From:	Dan Lister
Sent:	Monday, December 23, 2024 10:05 AM
То:	'wmason@masonandassociates.us'
Cc:	'mike.chidester@eltonco.com'
Subject:	SD2022-0037 - Cambridge Estates - Preliminary Plat
Attachments:	CR2024-0037 Cambridge Estates Subdivision - Nampa Comments.pdf; Initial Agency
	SD2022-0037 Cambridge Estates Subdivision.pdf; ITD.pdf; NampaAddressing.pdf;
	NHD1.pdf; SD2022-0037_Cambridge Estates Sub.pdf; Cambridge Estates_17672 N. Can
	Ada RdFire District Comments_V2.pdf; 2023.02.21 Full Preliminary Plat Checklist.pdf;
	NampaCCActionLtr_CambridgeSub_WaiverRequest_20220929.pdf

I've been assigned Case No. SD2022-0037—Cambridge Estates Preliminary Plat. Since the case has been sitting for a while, a courtesy notice was sent to affected agencies for updated comments. All comments received are attached.

- TO: Dan Lister, Canyon County Development Services
- RE: CR-2024-0037 Cambridge Estates

RE: Cambridge Estates Subdivision Preliminary Plat Review

# **RE: Cambridge Estates Road Name Changes**

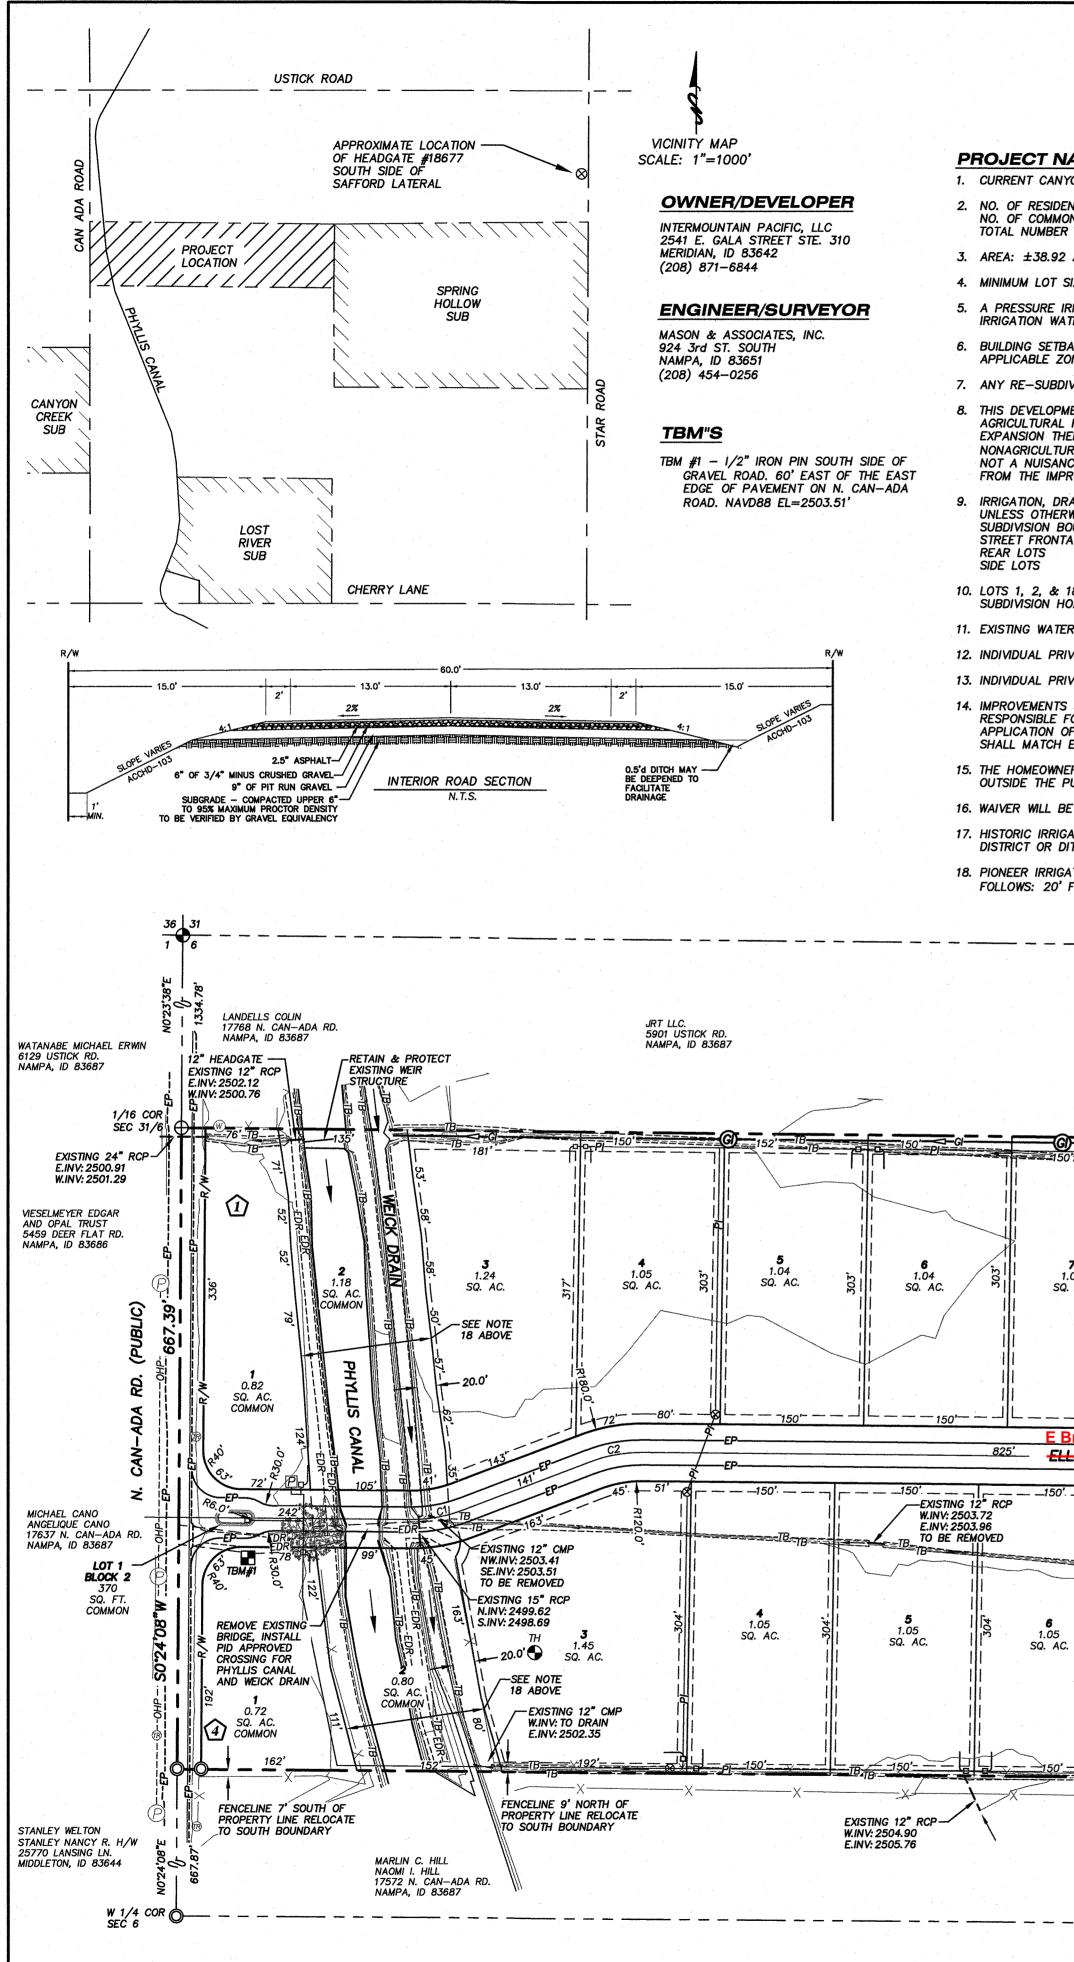
The Applicant shall submit an updated site plan or draft copy of the plat to City of Nampa Engineering GIS staff reflecting these changes prior to final plat application submittal.

• Ellingwood St should be E Breitenbach St. This future road will be a continuation of E Breitenbach St in the Spring Hollow Ranch Subdivision

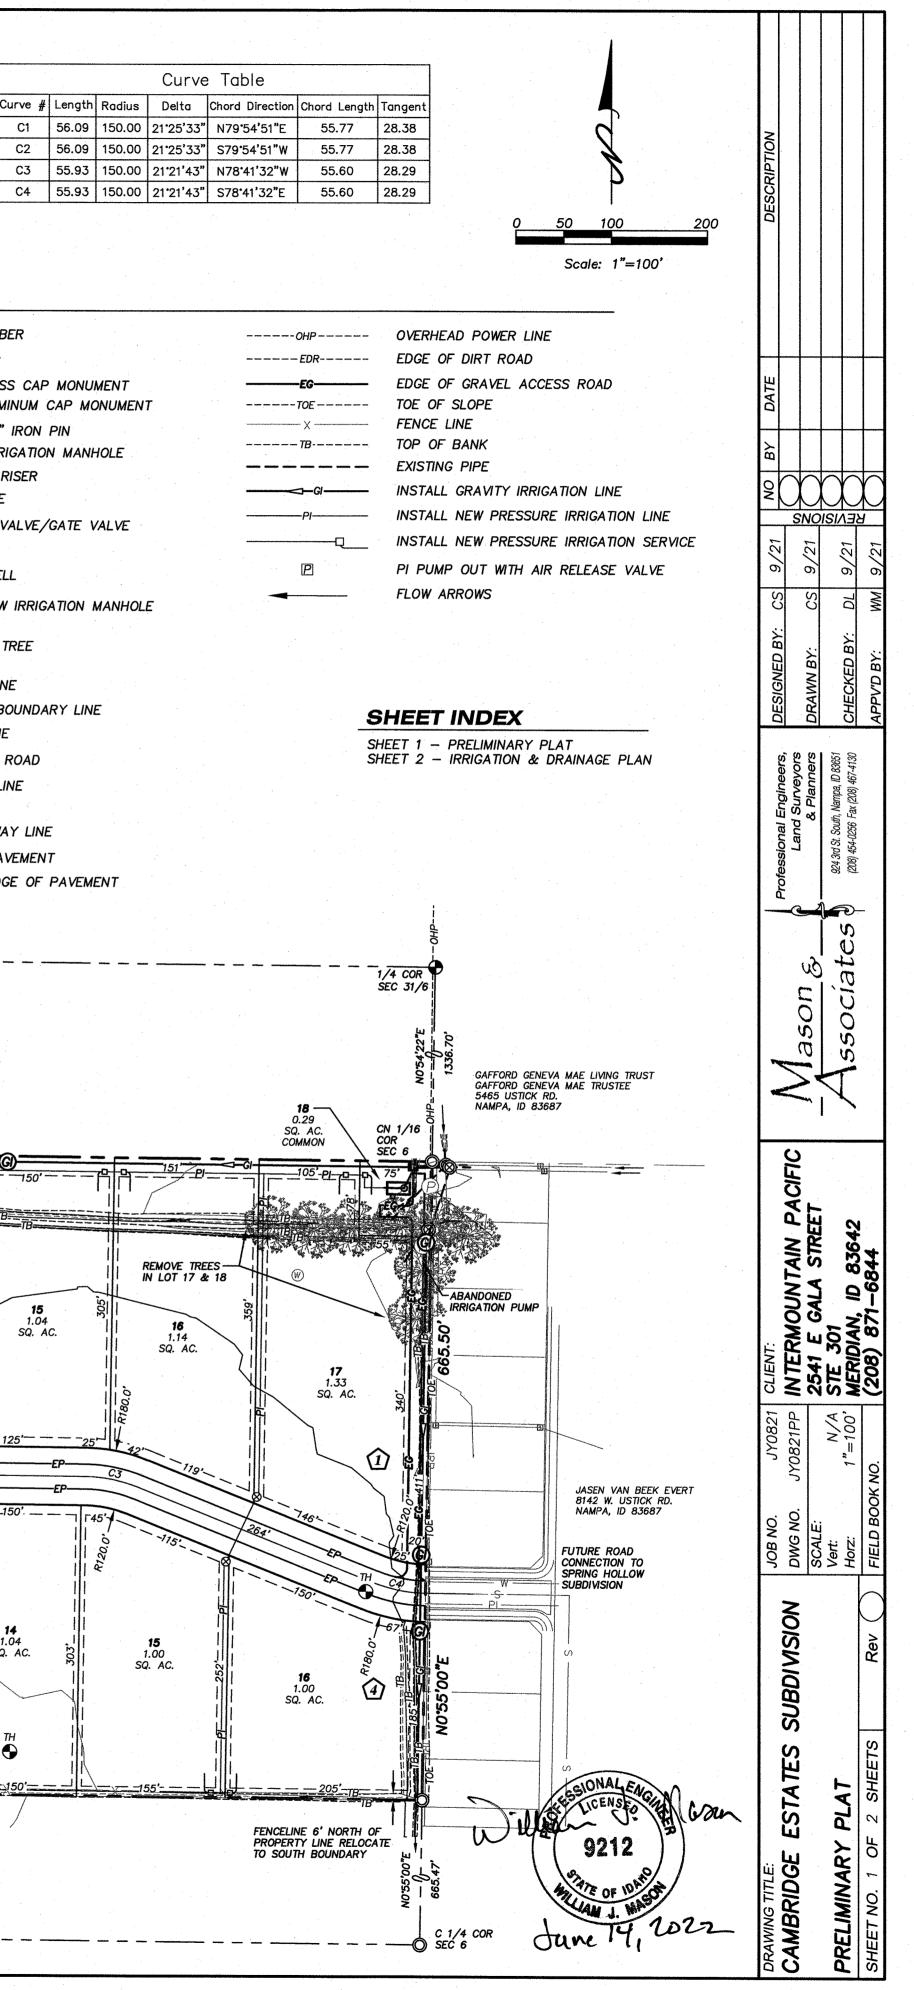
Section 2030.021 – Vicinity Map shall extend 1 mile beyond all boundaries.

Section 3030.030 – A Temporary cul-de-sac is required at the end of E. Breitenbach St.until the road is extended to the adjacent development to the east. It is to be built per ACCHD Standards Drawing #ACCHD-104.

Section 3030.040 – E. Breitenbach St. shall connect to Can-Ada Rd. by a 40' radius. Radiuses shall apply to asphalt and right-of-way.

Section 3060.050 – Access island and midpoint island requires an approved License Agreement. NHD#1 prefers the islands to be part of the ROW rather than being lots owned by the HOA. Islands shall be designed per ACCHD Standards Drawing #ACCHD-108.

Per Section 3061.070 - add a note on the plat stating "No access shall be allowed to land in a platted subdivision other than to internal subdivision streets or as otherwise shown on the plat".

Section 3070.040 – Borrow ditches shall be designed to convey stormwater runoff and shall not be designed for stormwater disposal through infiltration. Note 11 swales are not to be in the ROW.

## PRELIMINARY PLAT REVIEWED ON:

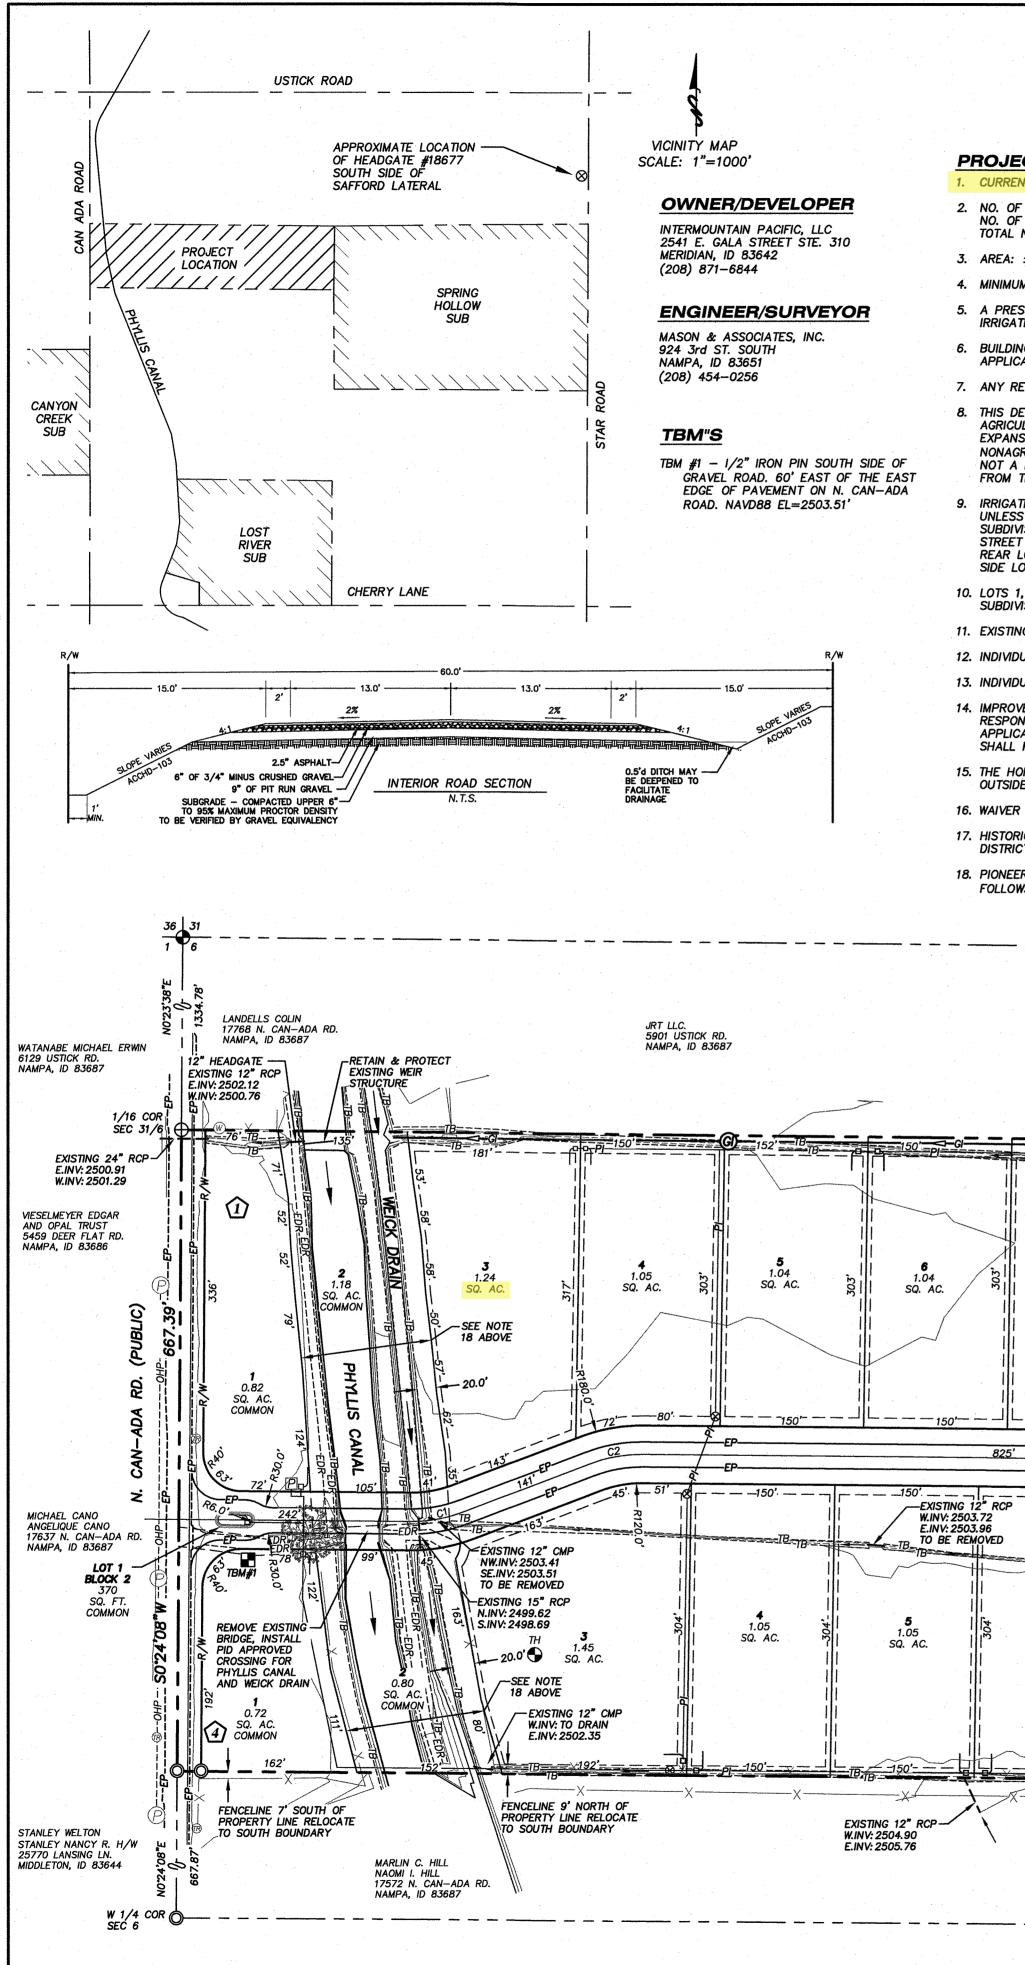
C. EXISTING CONDITIONS DATA	Meets Code / Comments
1. 2 Foot Contours shown unless otherwise approved; show all areas in excess of 15% slope	Meets Code
2. Location of water wells, streams, canals, irrigation laterals, private ditches, washes, lakes or other water features; direction of flow; location and extent of known areas subject to inundation.	Meets Code
<ul> <li>3. Location, widths and names of all platted streets, railroads, utility rights of way of public record, public areas, permanent structures to remain including water wells and municipal corporation lines within or adjacent to the tract</li> <li>Future use of remaining wells, if applicable</li> </ul>	Please dimension the Can Ada width

N/A
Although, being prepared to describe (to the planner or hearing bodies) how the planned timing of the adjacent phase of Spring Hollow compares to the timing of Cambridge wouldn't hurt since future connection is shown.
N/A
Meets Code
Meets Code / CommentsIn order to minimize adverse conditionsthis parcel would most appropriately beserved by City of Nampa Utilities. Which,according to a 1/30/23 email from Cityof Nampa, would require annexation.Comments below are given based on thecurrent plan for utilities.
Meets Code
<ul> <li>The preliminary nutrient pathogen study results provided show 65% reducing system should keep increases in groundwater nitrate concentrate below the relevant threshold. However, there is currently no effective regulatory mechanism to ensure those systems are monitored as required. Basically, DEQ told SWDH to handle it but SWDH told DEQ they don't have the man power. And now they hardly see any annual reports for these systems come in.</li> <li>Is there any way the developer can help ensure the maintenance and reporting happens so these systems provide the</li> </ul>
